NOTICE OF SPECIAL MEETING OF THE CITY COUNCIL OF THE CITY OF HARKER HEIGHTS, TEXAS

3. Discuss and consider approving a Preliminary Plat referred to as The Sanctuary at Harker Heights Preliminary Plat, being 68.90 acres of land out of the James M. Cross Survey, Abstract No. 179 and the W.H. Webb Survey, Abstract No. 1016, Bell County, Texas, and being all of a called 20.00 acre tract of land as described by a deed to C.A. DOOSE & COMPANY, a Texas Corporation, recorded in Document No. 2022017402, Real Property Records in Bell County, Texas, and being all of a called 48.91 acre tract of land as described by a deed to said owner recorded in Document No. 2021051936, of said Property Records. (Planning Administrator)

4. Discuss and consider approving a Final Plat referred to as Ranger Top Addition Final Plat, a 1.003 ACRE, situated in the Elizabeth Dawson Survey, Abstract 258, Bell County, Texas, and being all of that certain tract described as 1.0 acre in a General Warranty Deed with Vendor's Lien, to Ranger Top, LLC., recorded in Document No. 2022004499, Official Public Records of Real Property, Bell County, Texas. (Planning Administrator)

PRELIMINARY PLAT

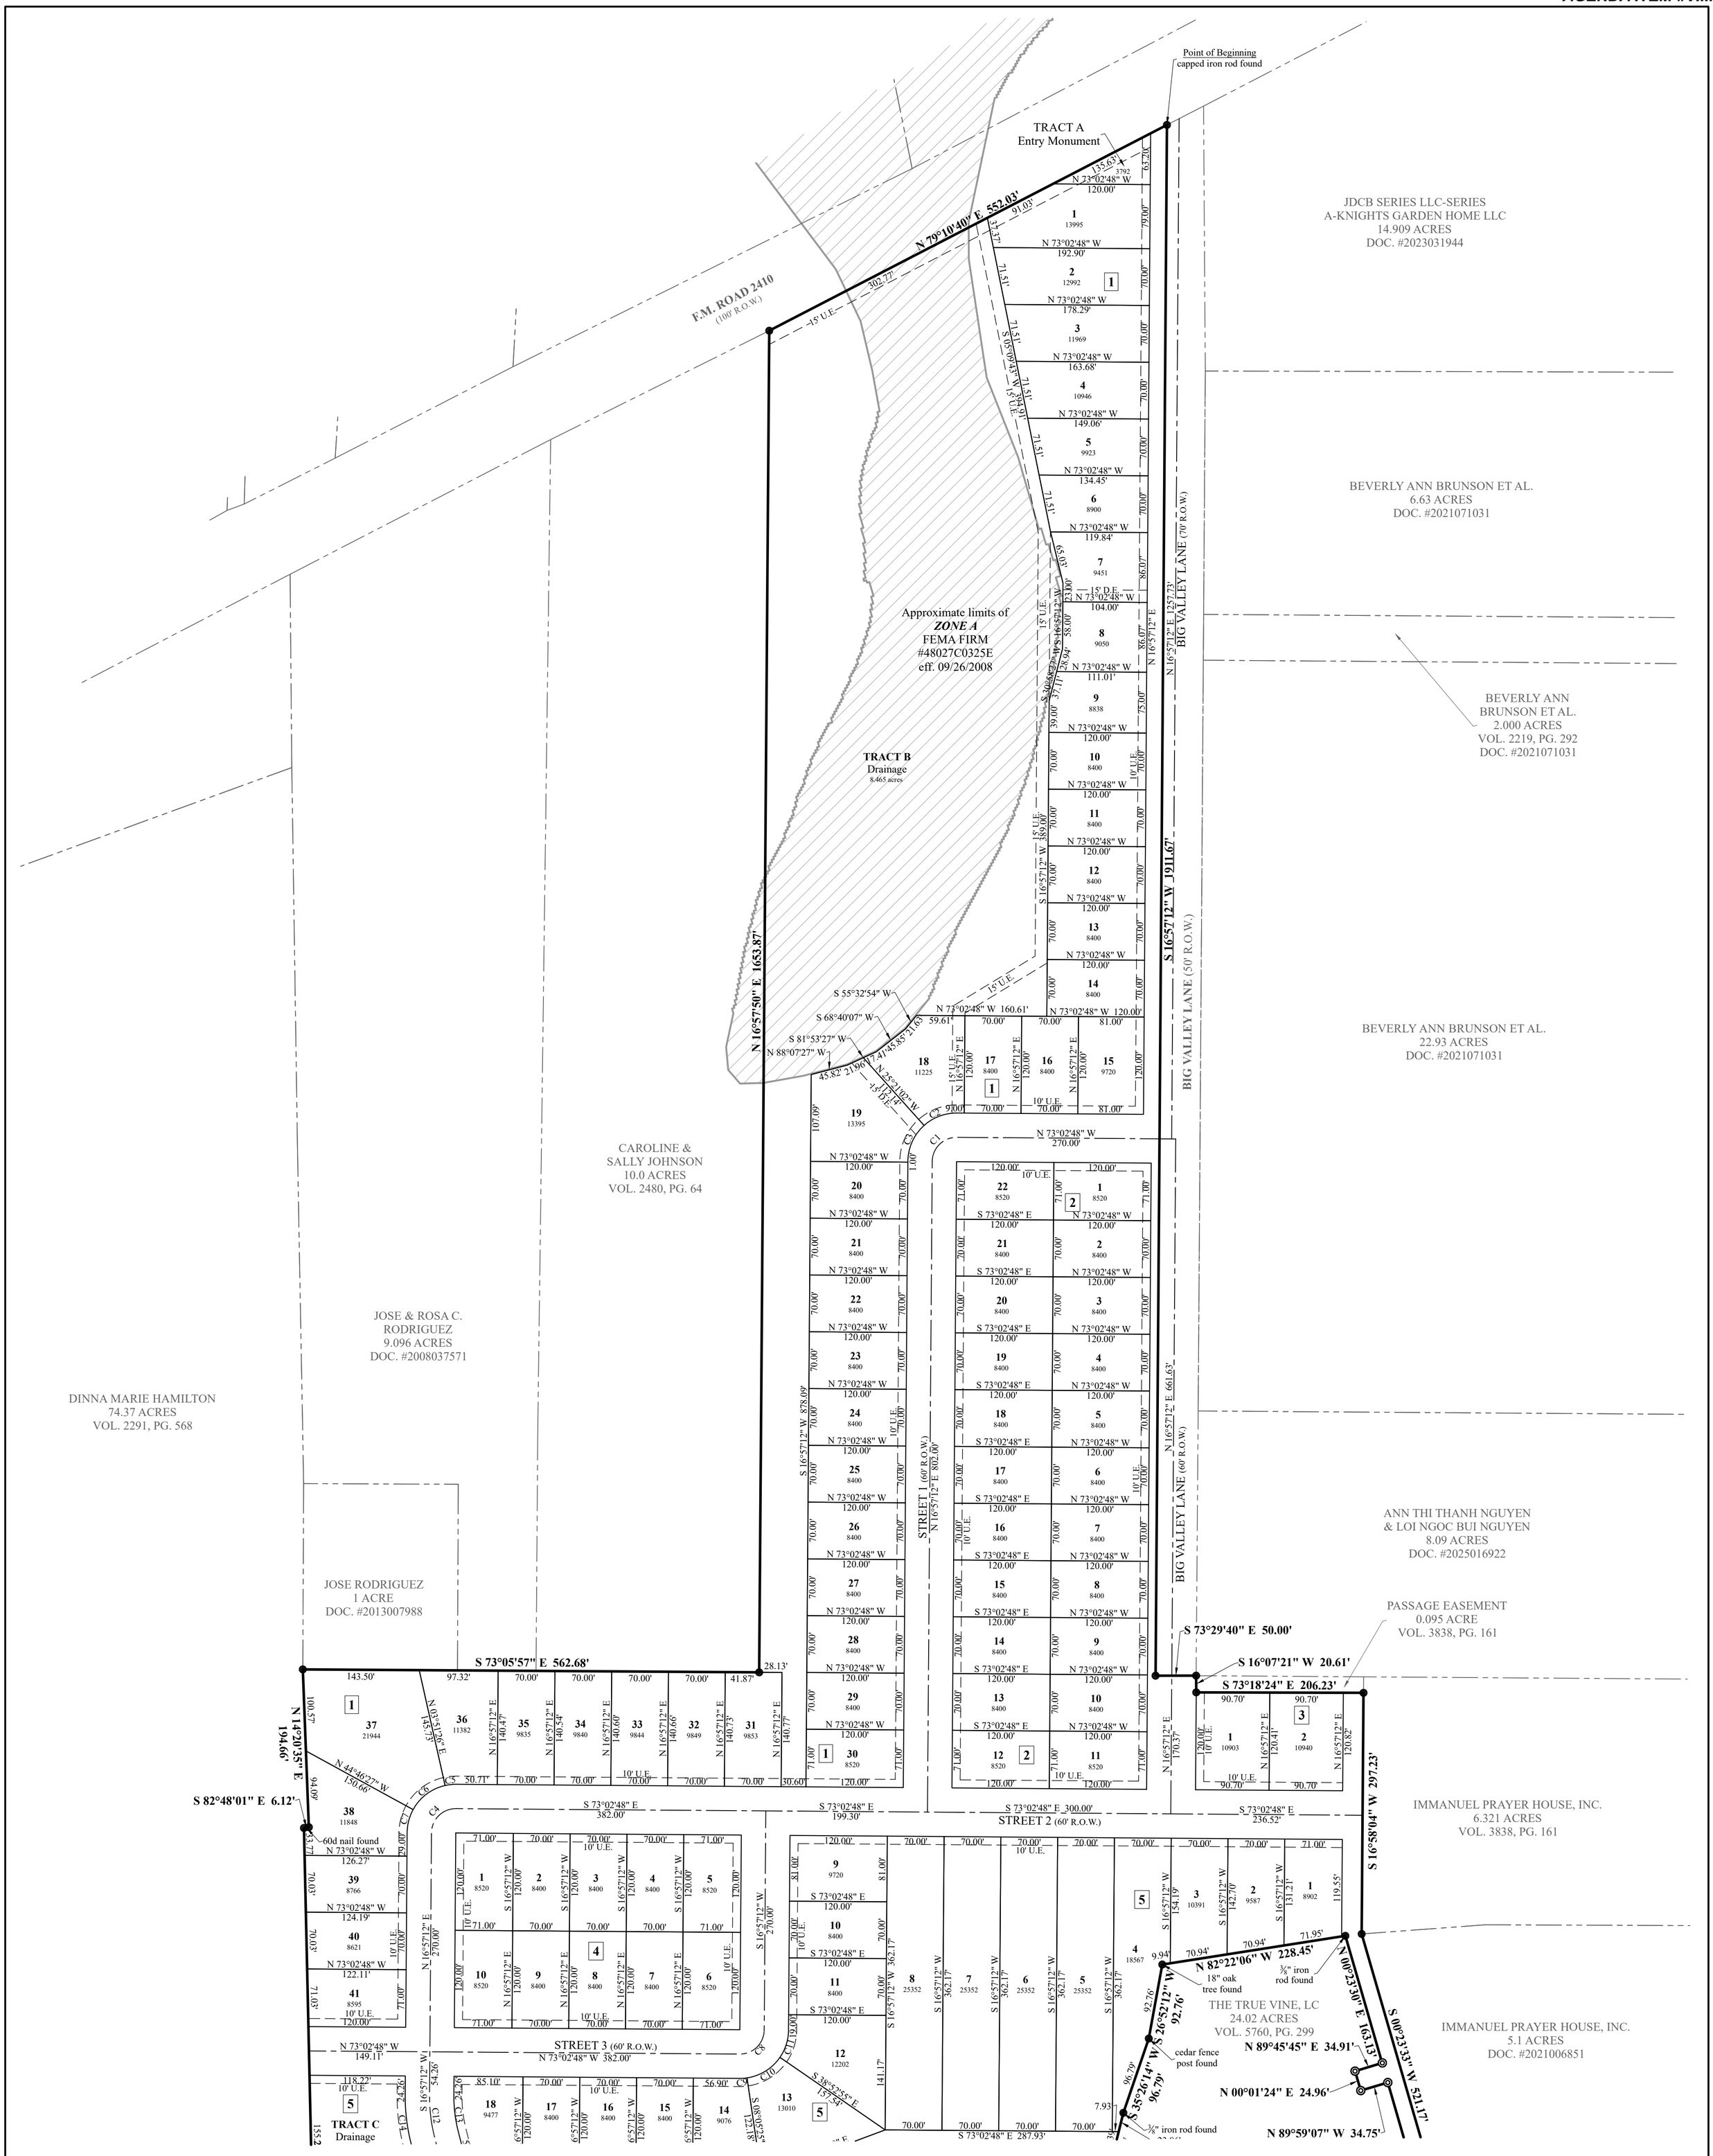
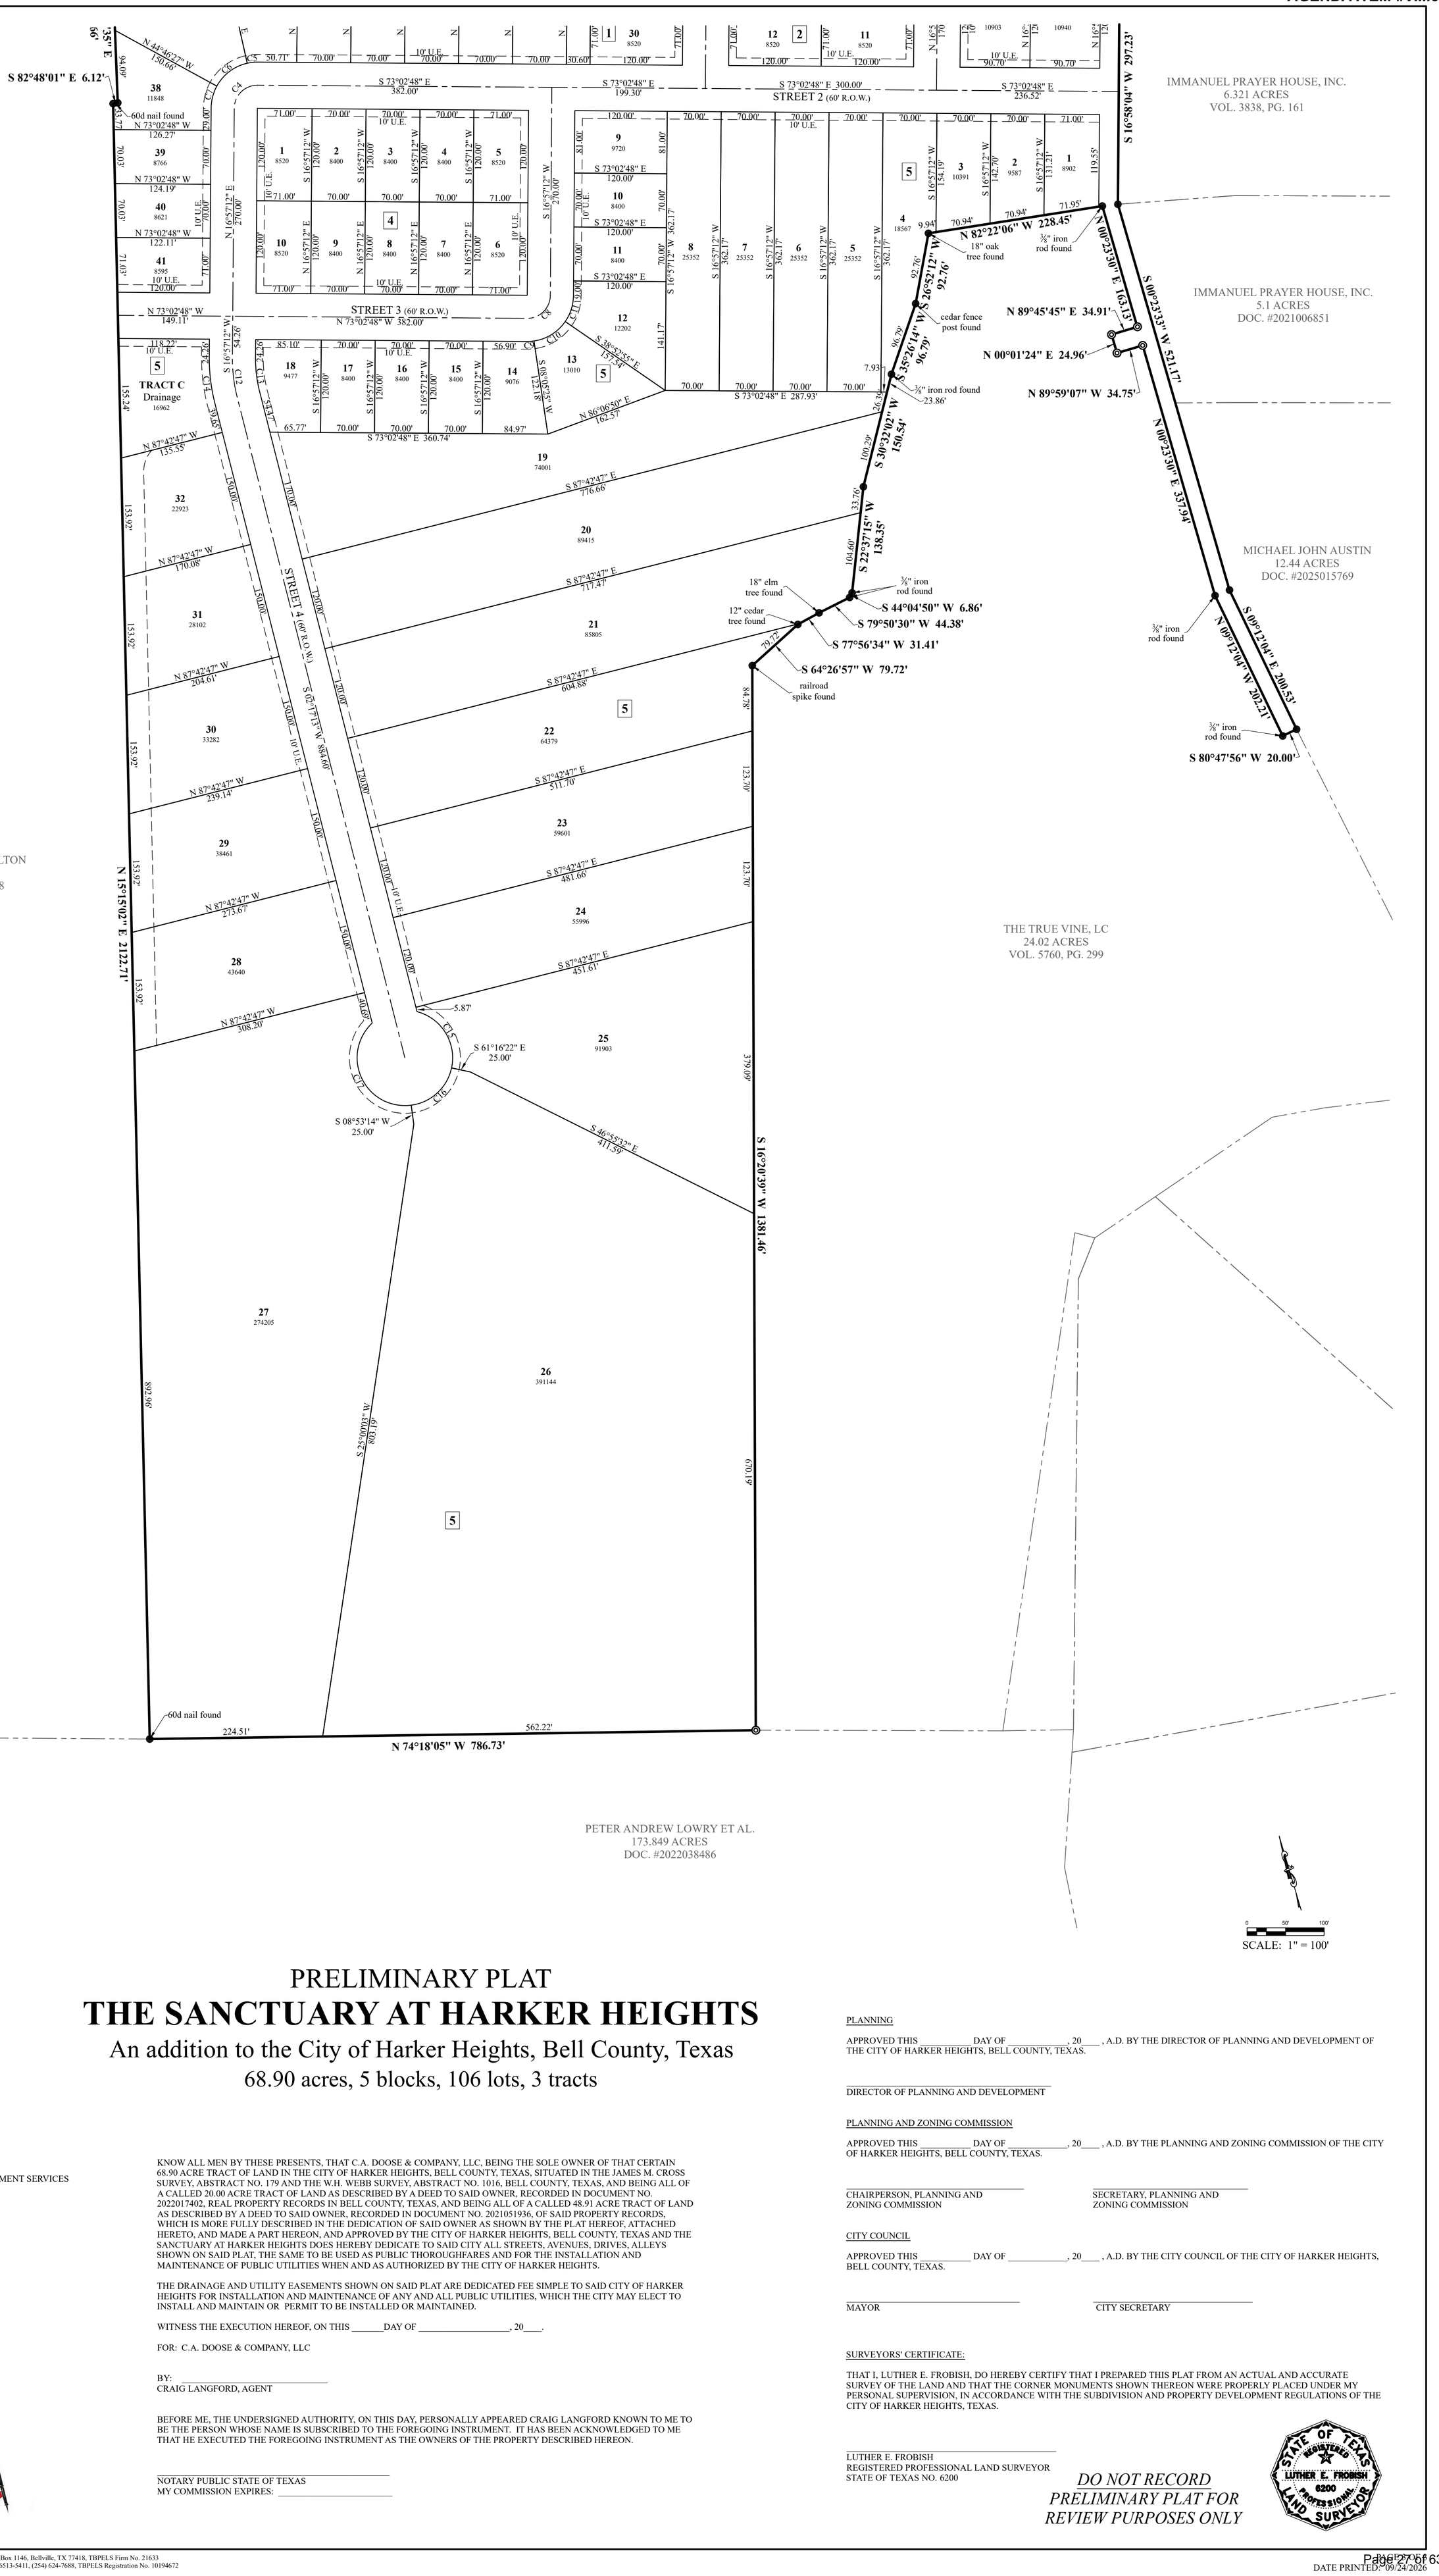
1. § 158.10 Floodplain Management. (C) Coordination of City of Harker Heights and FEMA floodplain delineations. For all subdivisions developed adjacent to or within non-detailed designated FEMA floodplains, the applicant/ developer shall be required to provide a detailed study to determine the Base Flood Elevations (BFEs) for all lots that are adjacent or within the non-detailed area. The BFEs must be developed using approved FEMA guidelines and methods. A copy is to be furnished to the city prior to final plat.
2. § 154.37 (A) (3) Per Public works comments, the proposed entrance to the subdivision must meet the requirements as a collector and each lane must be a minimum of 24' wide.

1. Indicate all Public Utility Easements meet the minimum 15' width requirement for water and sanitary sewer utilities (§ 154.42(A)(1)). 15' Easements for Sanitary Sewer Utilities noted. 10' PUE's were indicated on submitted plans for Water Utilities.
2. Provide a street and sidewalk layout plan that includes the proposed street names (§ 154.2(C)(2)(D). Only one street name "Big Valley Lane" was noted on the submitted plans.
